APPEAL SUMMARY

Status: Decision Rendered**Appeal ID:** 15819**Project Address:** 2206 NE 42nd Ave**Hearing Date:** 9/13/17**Appellant Name:** Ajitkumar Aserappa**Case No.:** B-011**Appellant Phone:** 5039221223**Appeal Type:** Building**Plans Examiner/Inspector:** Preliminary**Project Type:** residential**Stories:** 2 **Occupancy:** R-3 **Construction Type:** V-B**Building/Business Name:****Fire Sprinklers:** No**Appeal Involves:** Alteration of an existing structure**LUR or Permit Application No.:****Plan Submitted Option:** pdf [File 1] [File 2] [File 3]
[File 4]**Proposed use:** Basement Stairs

APPEAL INFORMATION SHEET

Proposed Layout

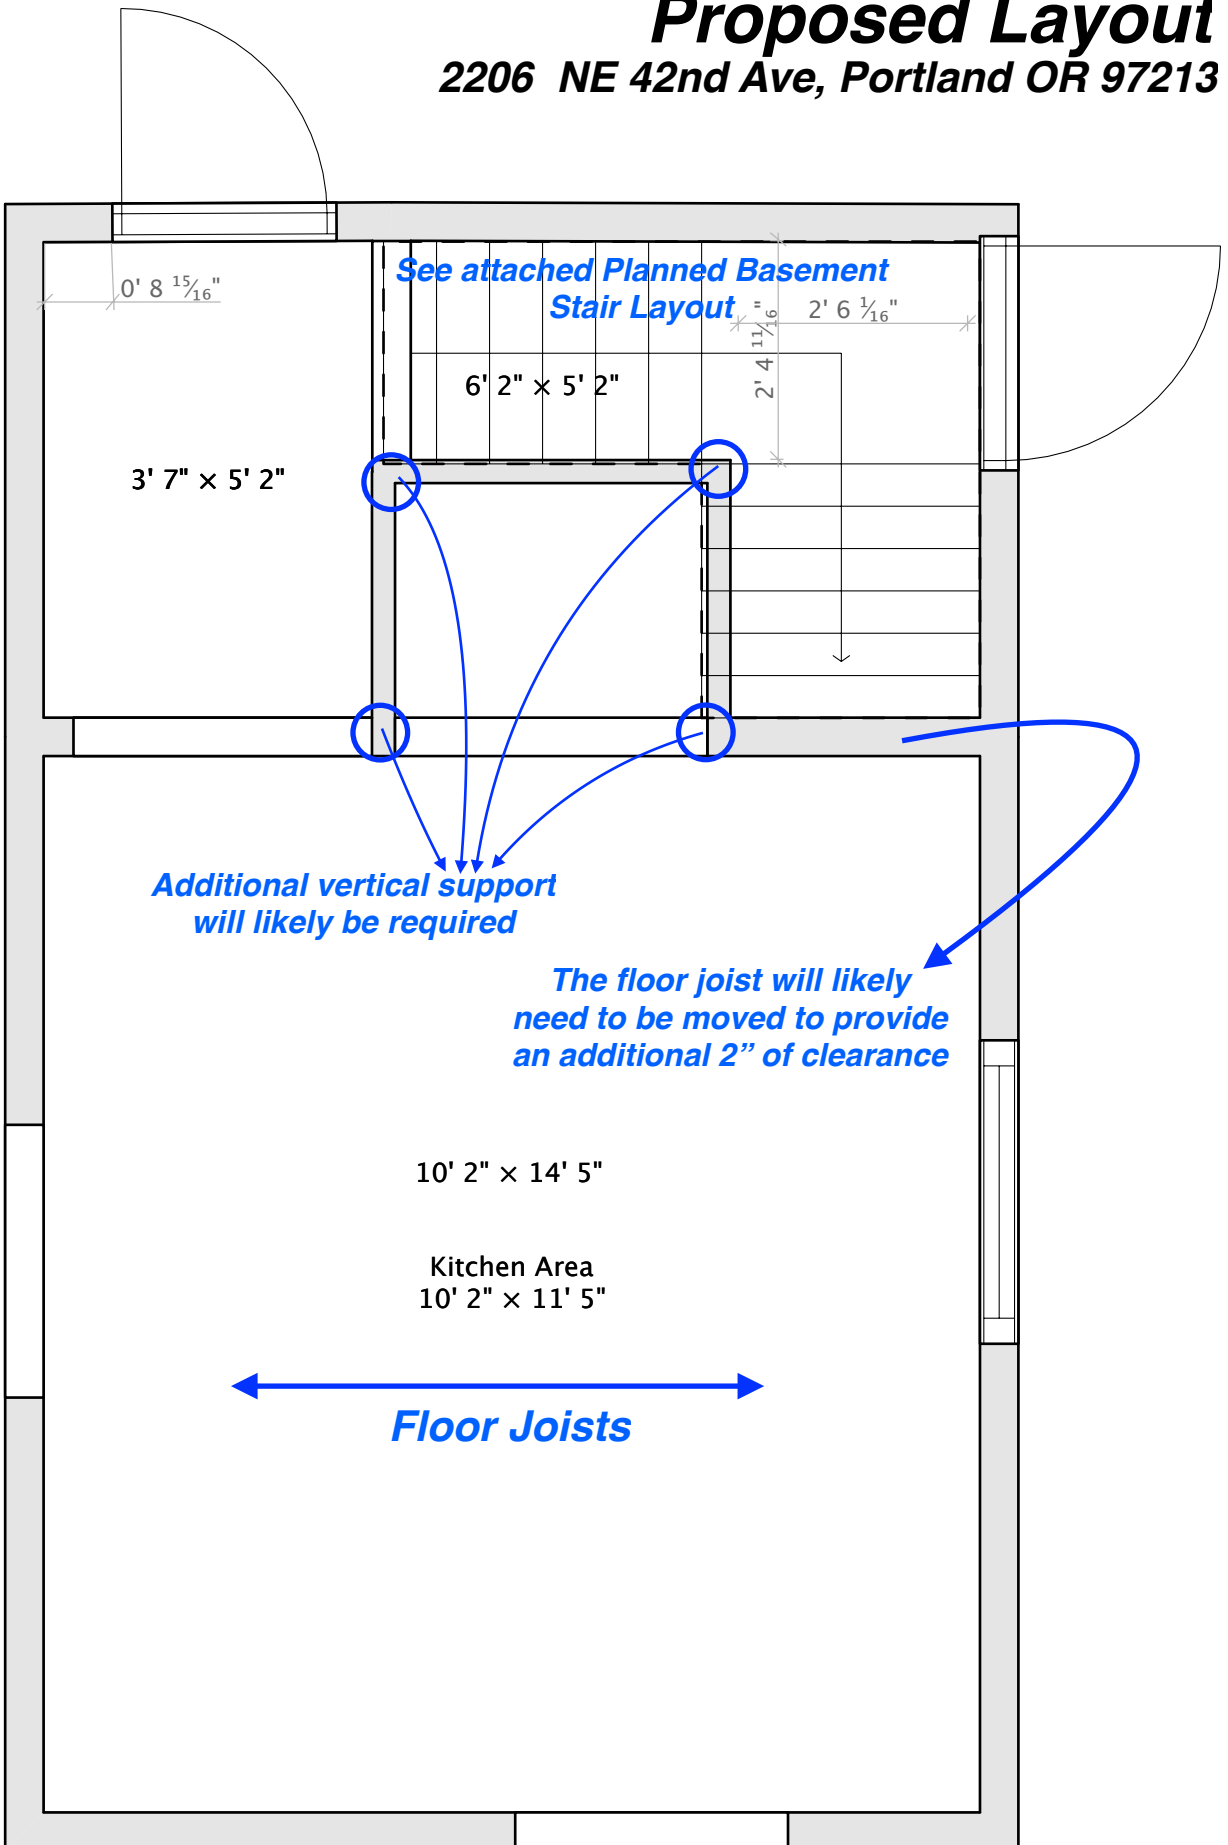
Code Section R311.7.2

Code Requirement – Headroom

- Headroom is the distance, measured vertically (plumb, straight up and down), between the ceiling or any projection from the ceiling, such as a beam, and a sloped line formed by placing a straight-edge along the nose of the stair treads.
- New stairs must have headroom of at least 6 feet 8 inches (except spiral stairs which may have headroom of 6 feet 6 inches).

The upper run of stairs will be completely code compliant with the two exception of R311.7.2 and R311.7.1. The stairs will have 9" tread and 8" risers accordingly. The headroom at the bottom of the stairs will be 6'2".

The new stairs will have 9" tread and 8" risers accordingly. The headroom at the foot of the basements stairs will be 6'2". All other areas provide for headroom of well over 6'8"s.

2. Reconstruction of stairway to basement, with reduction of allowed headroom to minimum 6'-2": Granted as proposed.

Note: the board approves minimum headroom of 6'-2" measured vertically from the lowest overhead element to a line that is tangent to the stair nosings.

Existing Basement Stair Layout

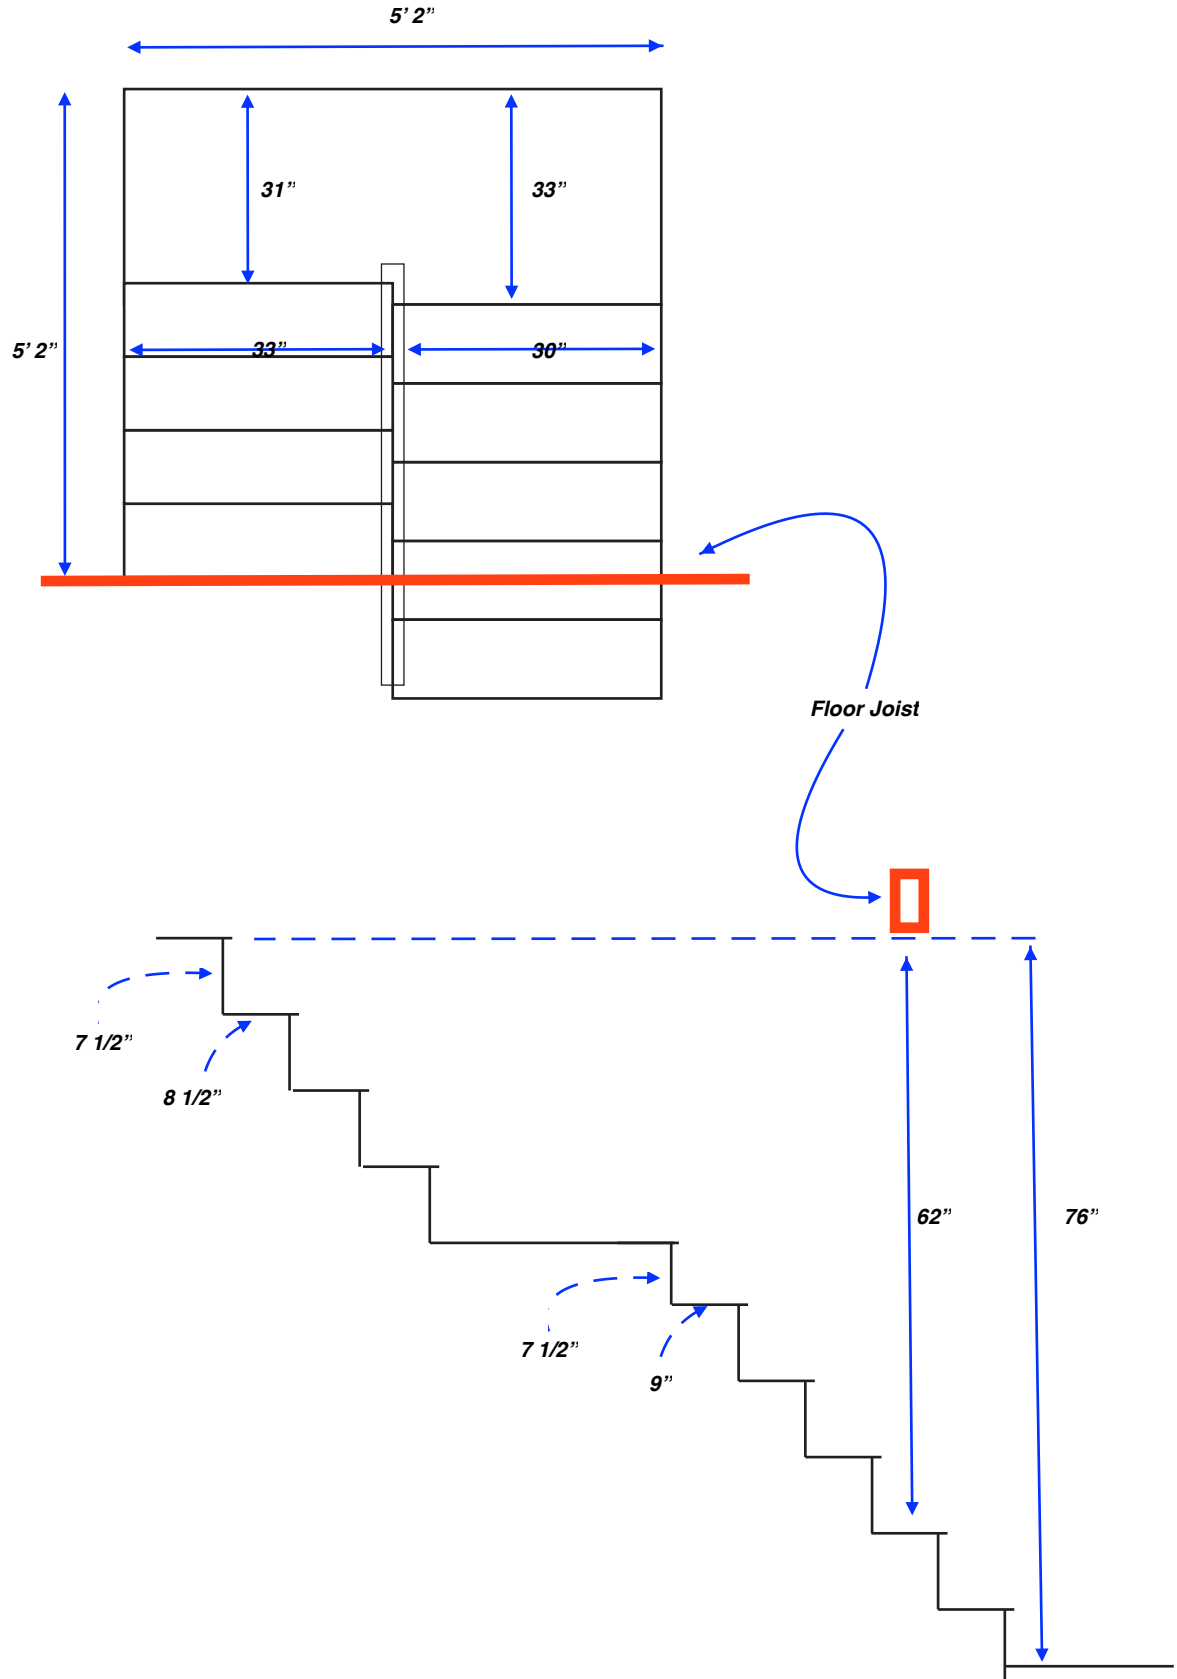
Proposed Design The proposed design relocates the stairs from the first floor to the basement. The existing stairwell from the first floor to the basement does not meet current code. The first row of existing stairs are 33" wide with 8 1/2" treads and 7 1/2" risers and the second (bottom) row of stairs are 30" wide with 9" treads and 7 1/2" risers. The current existing stairs are steeper than the new proposed stairs.

The proposed design relocates the stairs from the first floor to the basement. The existing stairwell from the first floor to the basement does not meet current code. The first row of existing stairs are 33" wide with 8 1/2" treads and 7 1/2" risers and the second (bottom) row of stairs are 30" wide with 9" treads and 7 1/2" risers. The current existing stairs are steeper than the new proposed stairs.

Basement Stair Layout Plan

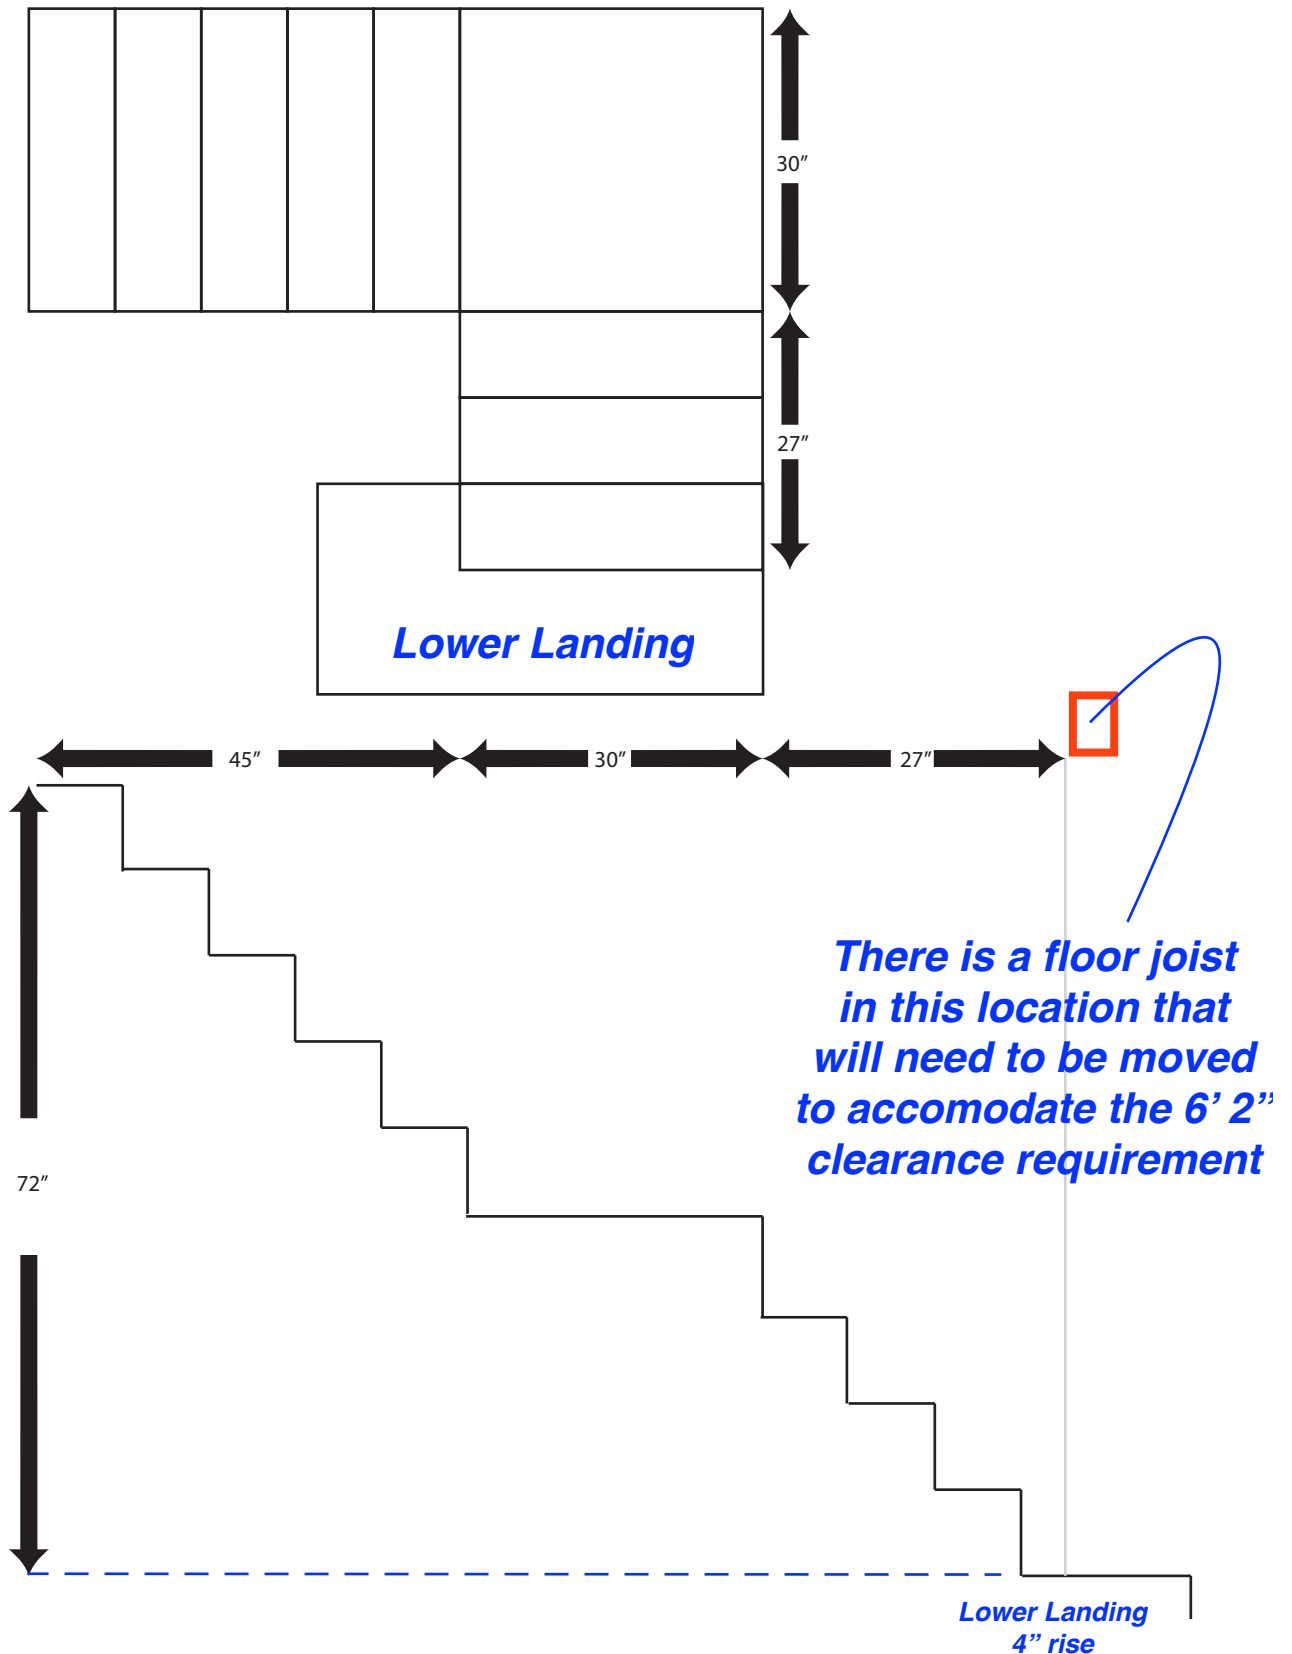
The existing stairs from the 1st floor to the basement are west facing. The relocated stairs from the 1st floor to the basement will be rebuilt with an entrance from the North. There is an existing door at grade level opening to the driveway to the north. The new stairwell will meet all ORSC R311.7 requirements except for two points - R311.7.1 - 36" Wide from Wall to Wall and R311.7.2 - Headroom requirements.

The upper run and lower run of stairs will have a minimum width of 30". The lower landing will be 30" by 30" to match the width of the steps. The new landing will be lowered approximately 12" to achieve a clearance of 6'2" at the base of the stairs. The new stairs will have a 9" treads and an 8" risers.

1. Reconstruction of stairway to basement, with reduction of allowed landing / stair width to minimum 30": No appeal required.
